Community and Stakeholder Engagement Report

Queenscliff to Freshwater Shared Path

Report date: 21 October 2020

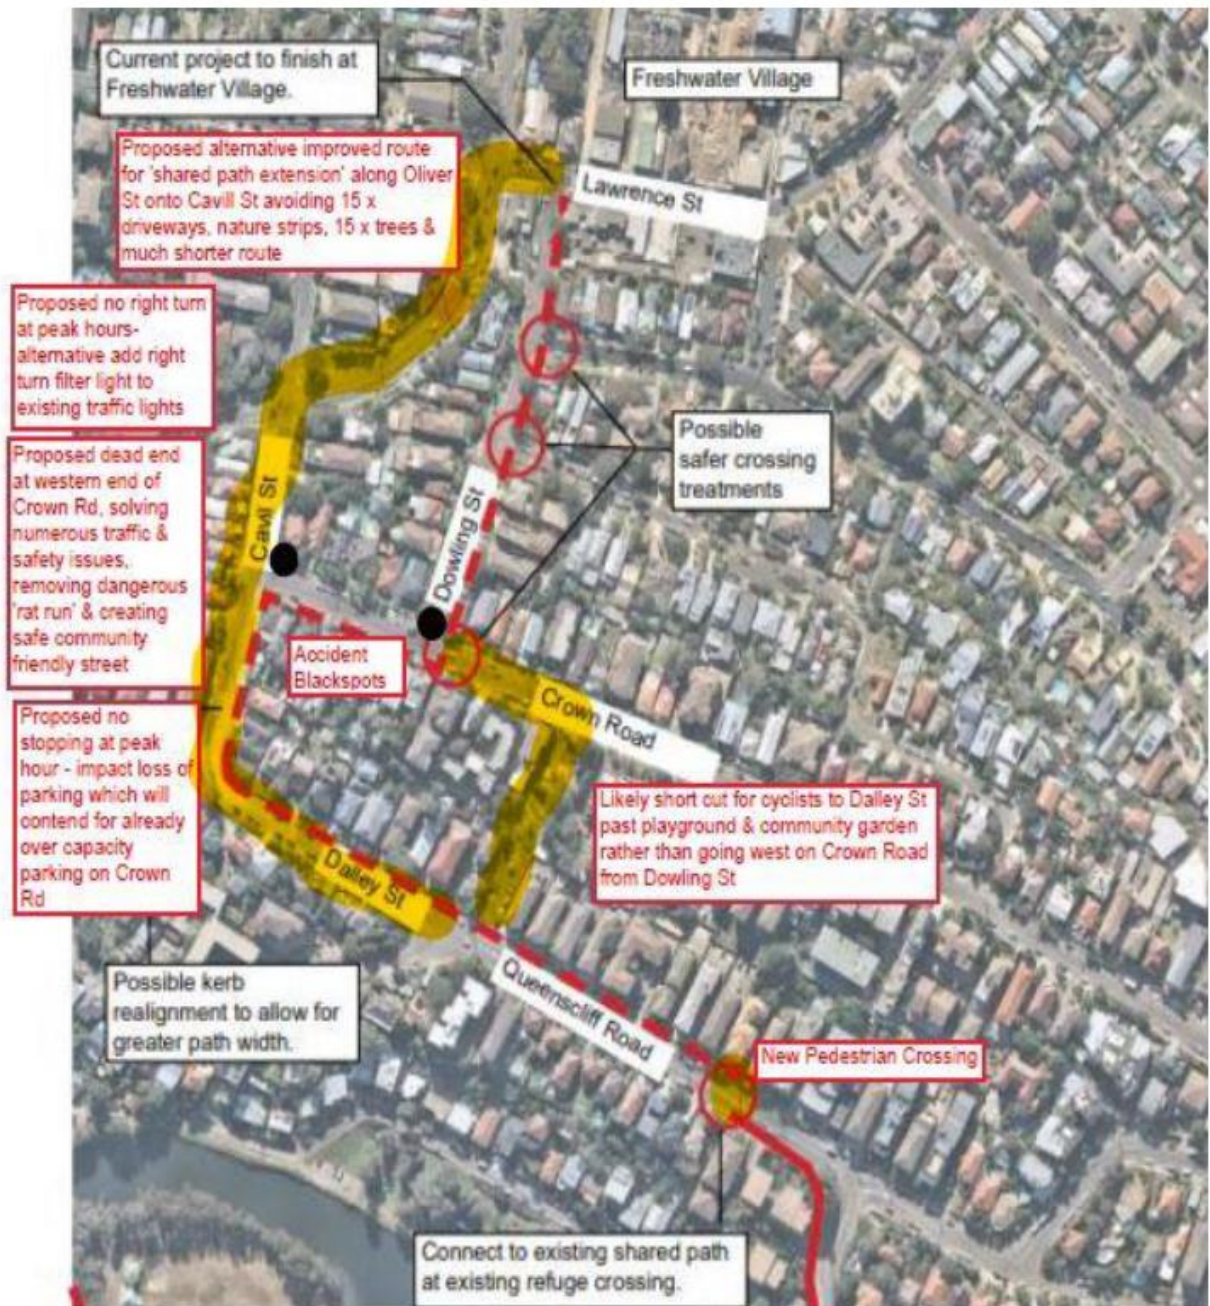
3. The western end of Crown Road should be closed off to traffic permanently at Cavill St.
4. There is no requirement for a 'no stopping right turn ban' at peak hours north bound at Cavill & Oliver St, instead a filter arrow on the existing traffic lights would solve any perceived minor traffic problem, which in our view does not exist.
